NSRP #0349
May 1992

P-52 Balloting of Hull
and
Mechanical Standards

Panel SP-6

FIGURE 3

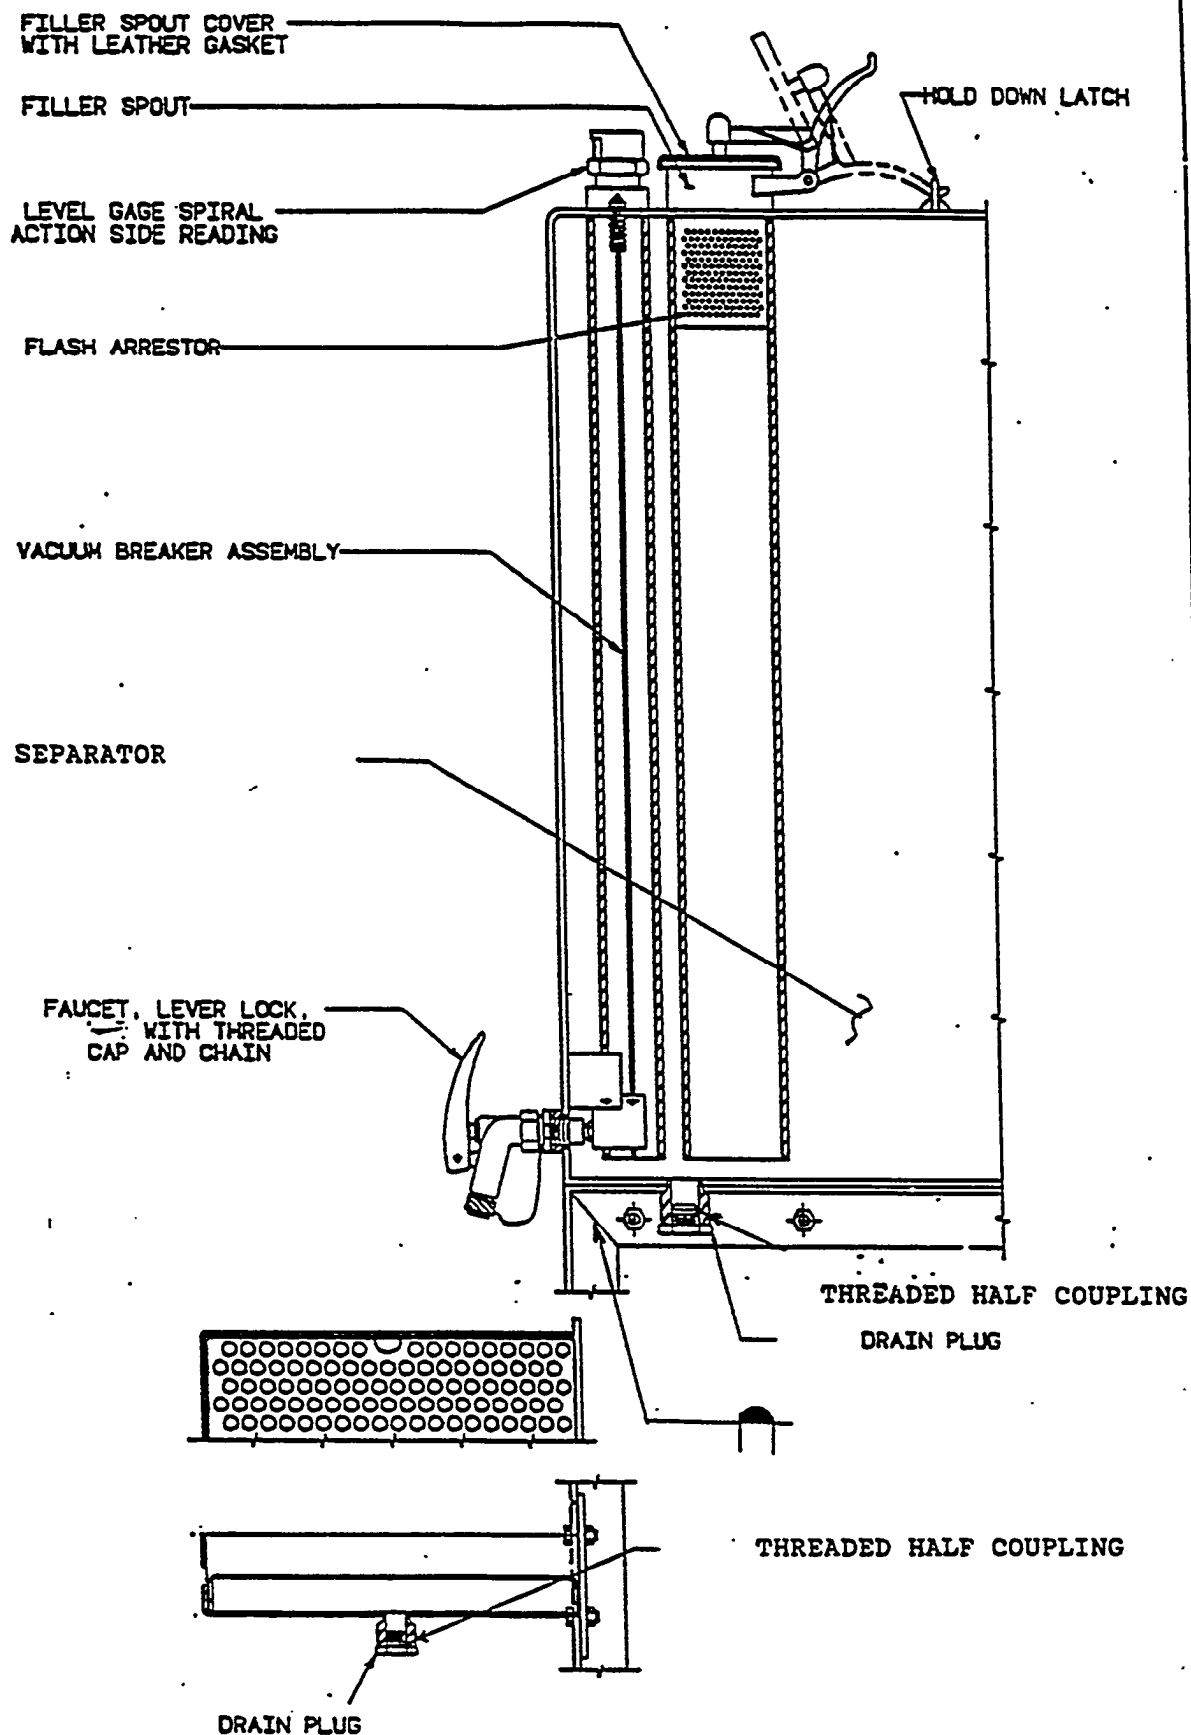
| 13. Fig. 3 - Under Label revise to show (See 6,4). | Concur |

FIGURE 1. CLEAT PAD, MARINE HARDWARE

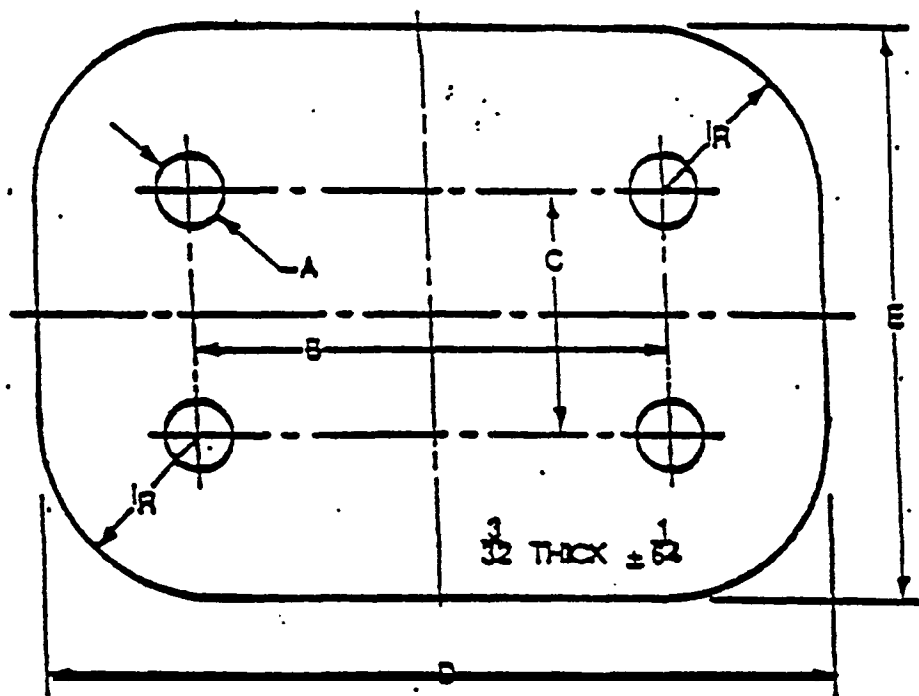
| 12 Figure 1-Dimension extension . lines should not cross. | Disagree - This will not harm the spec . |

3. In Figure 1, change Figures under "M" to 1 3/8".

FIGURE2 CLEAT, MARINE HARDWARE

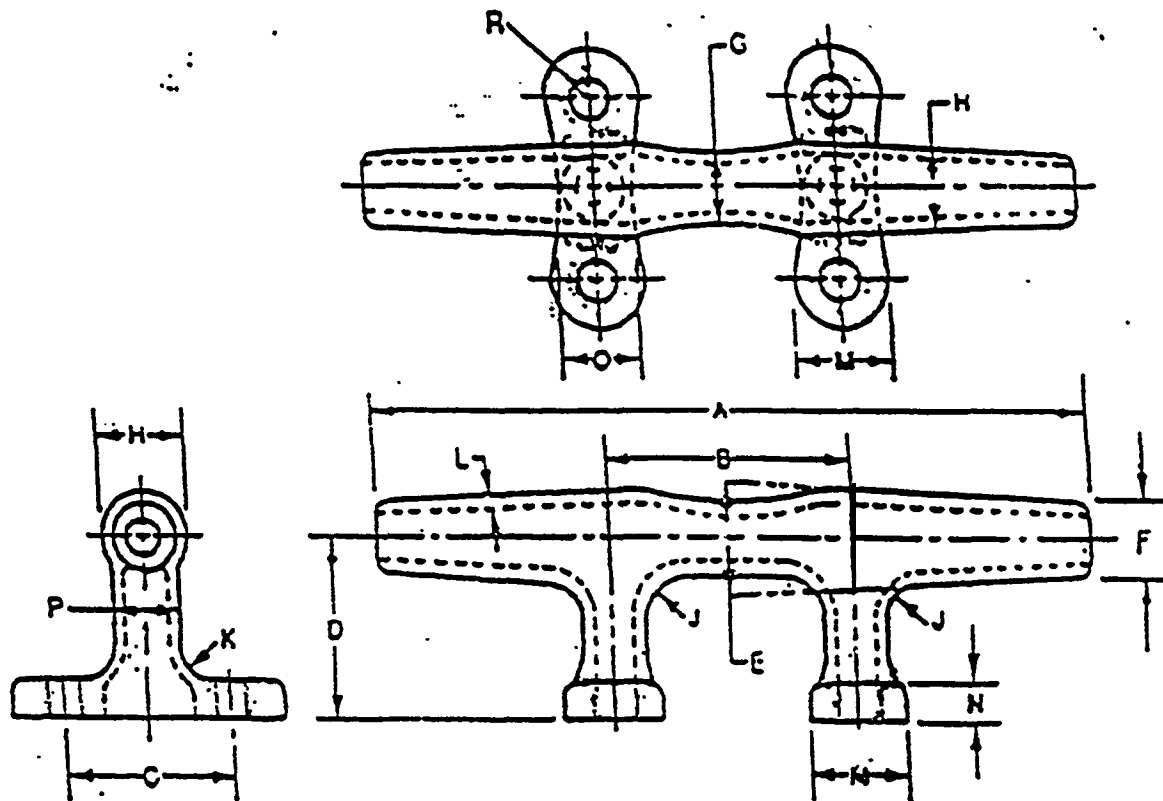
11. Figure 2 - Delete "Hollow".

28. Questionable whether F593 is correct, since Fig.2 is shown as drilled & counter-sunk making flat or CSK head mach. screws.... Concur - Modified Fig.2 to suit.

PLAN VIEW
FIGURE 1

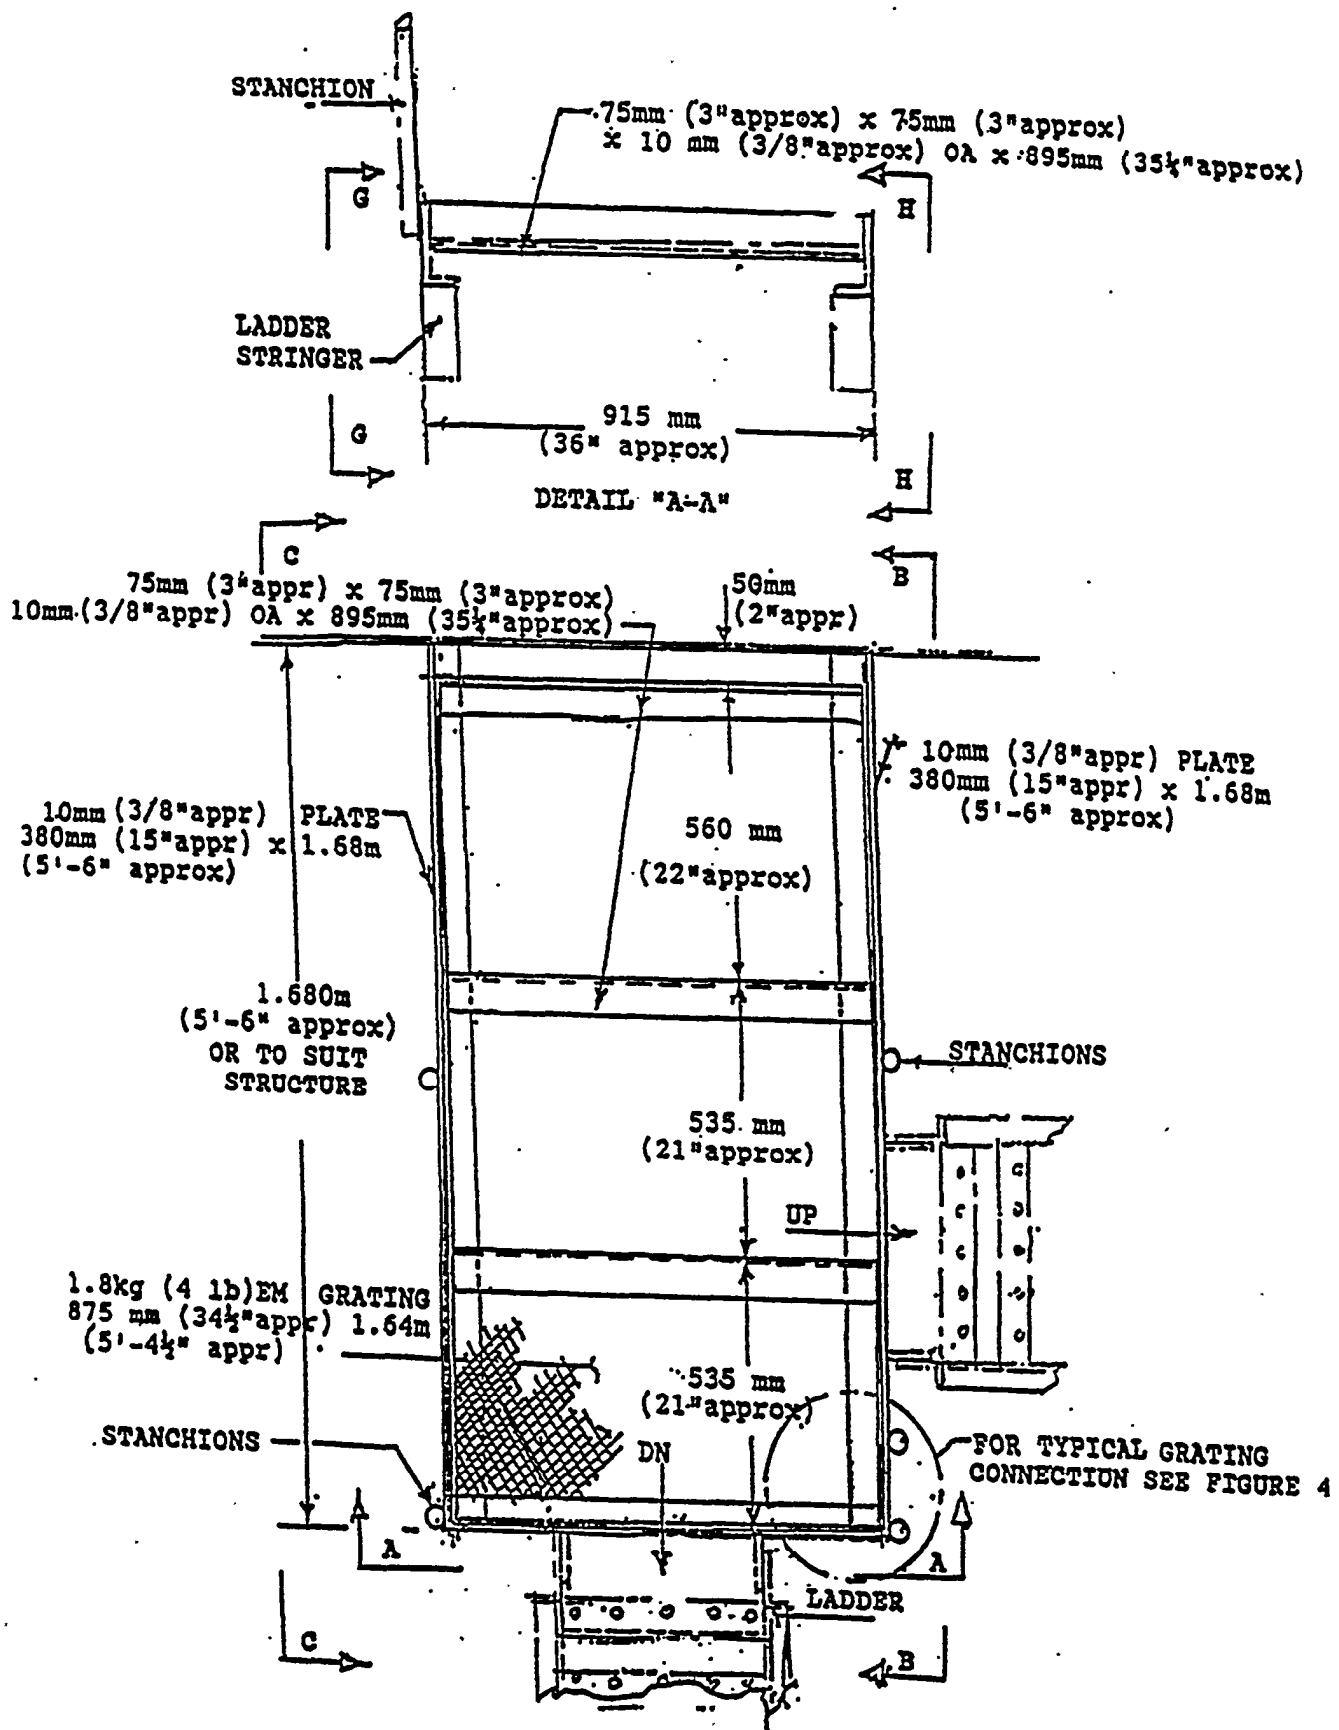
20. Fig.1 - Change all 9.5mm to 9mm.

FIGURE 2

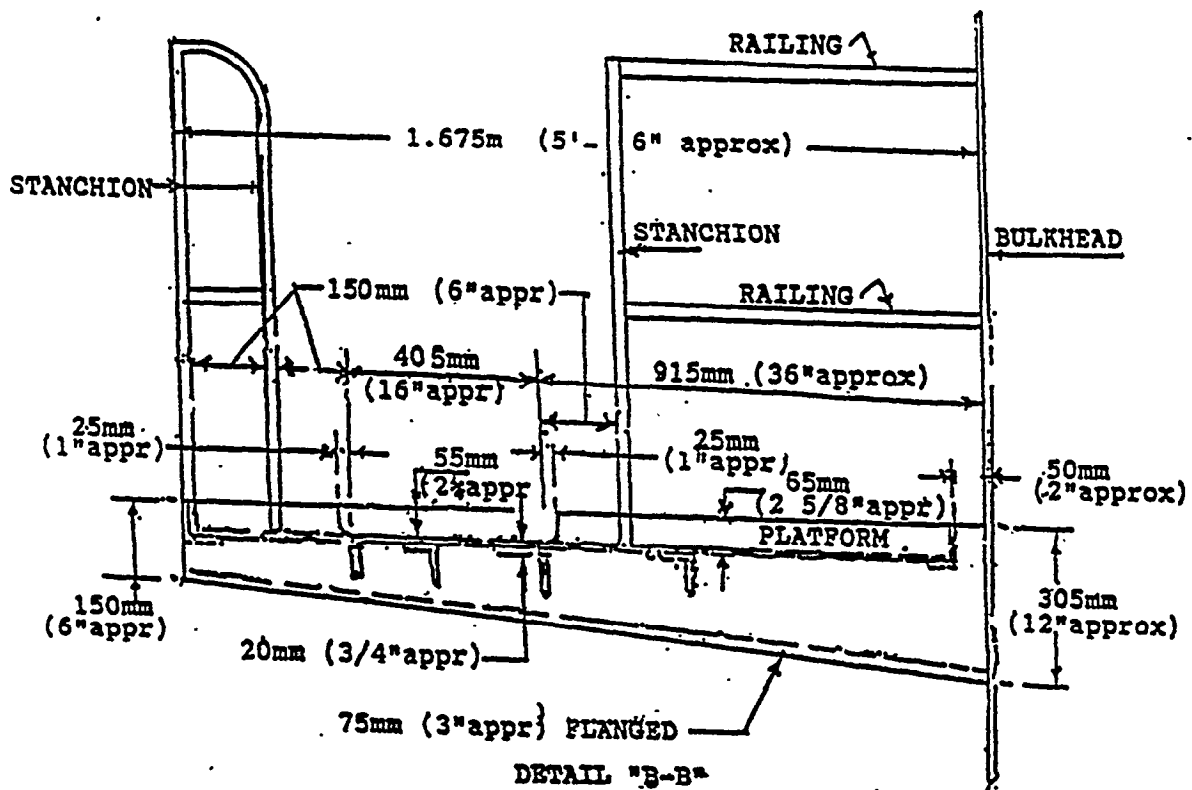
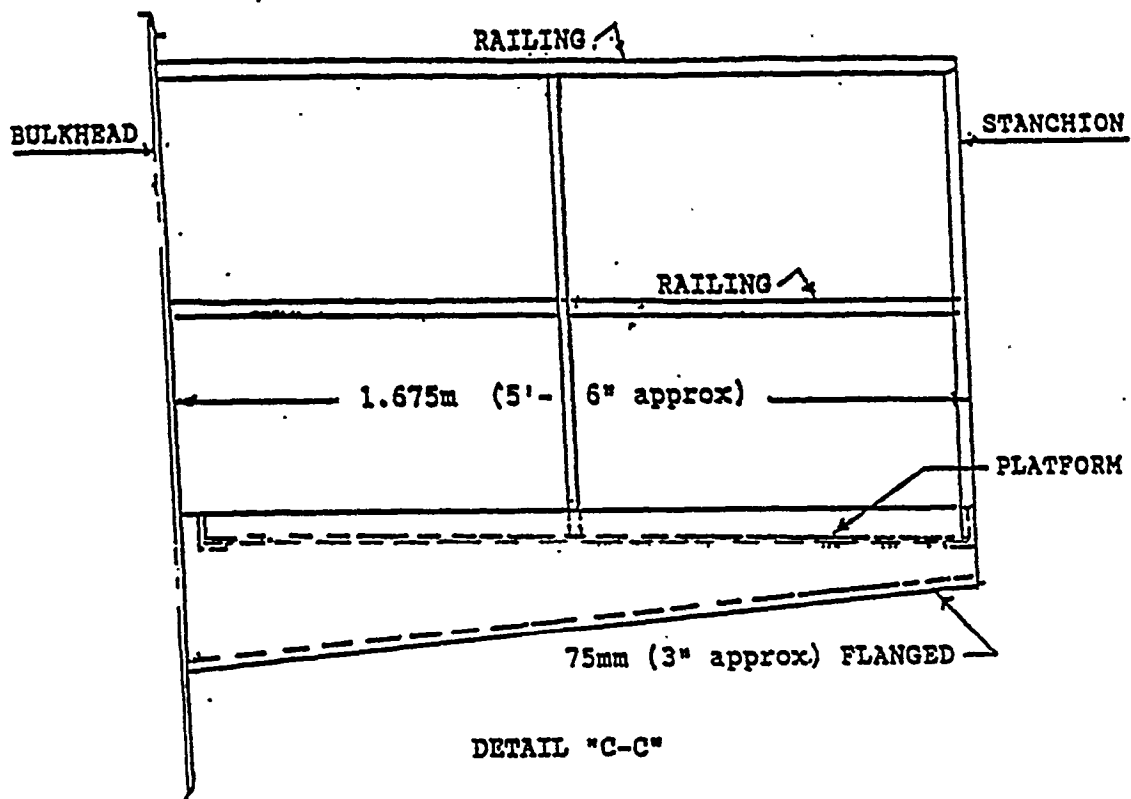
21. Fig. 2 - Change "406" to "405".

FIGURE 3

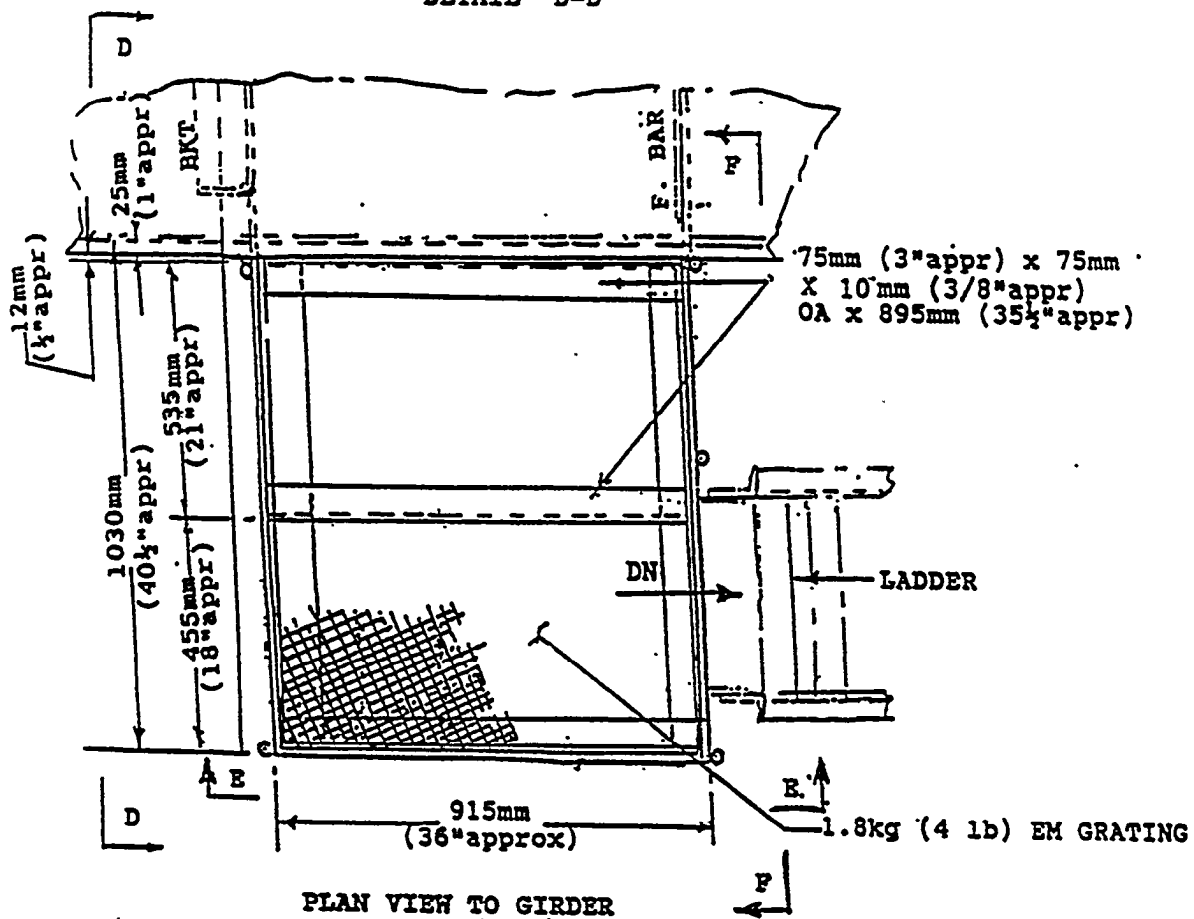
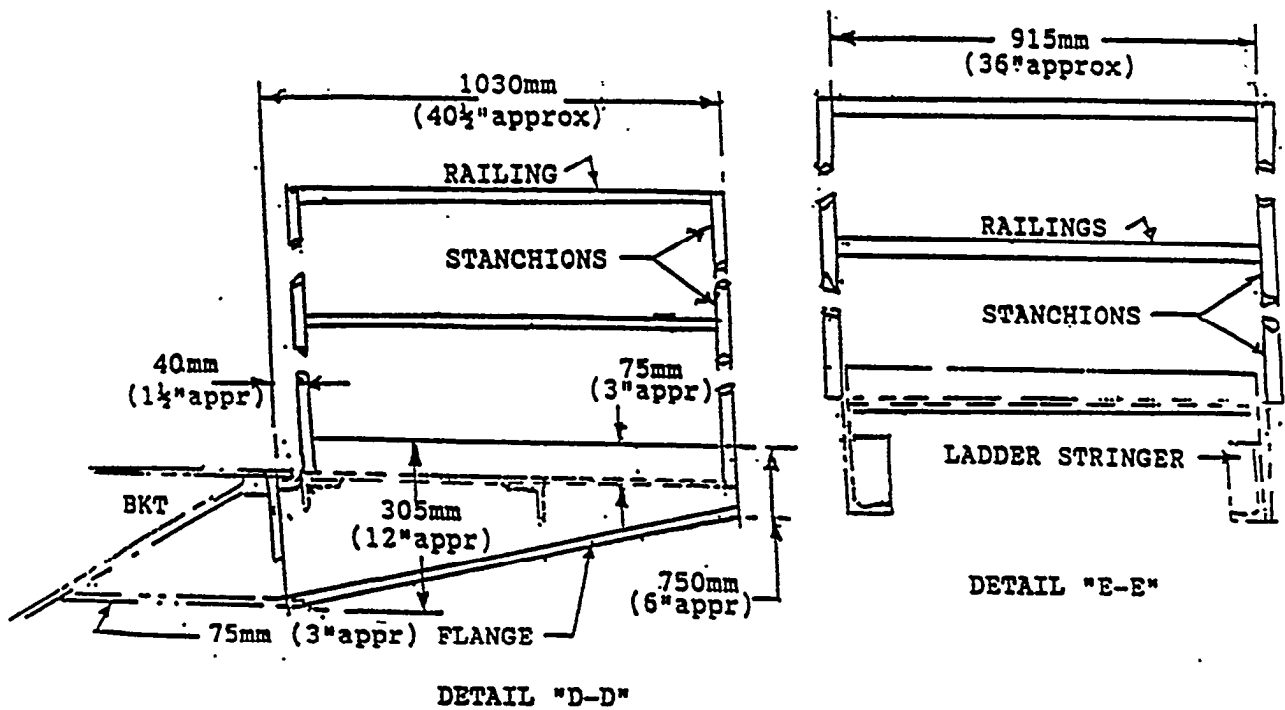
22. Fig..3 - Change 1028 to 1030. 38mm to 40mm, 458mm to 455mm, & 533mm to 535mm.
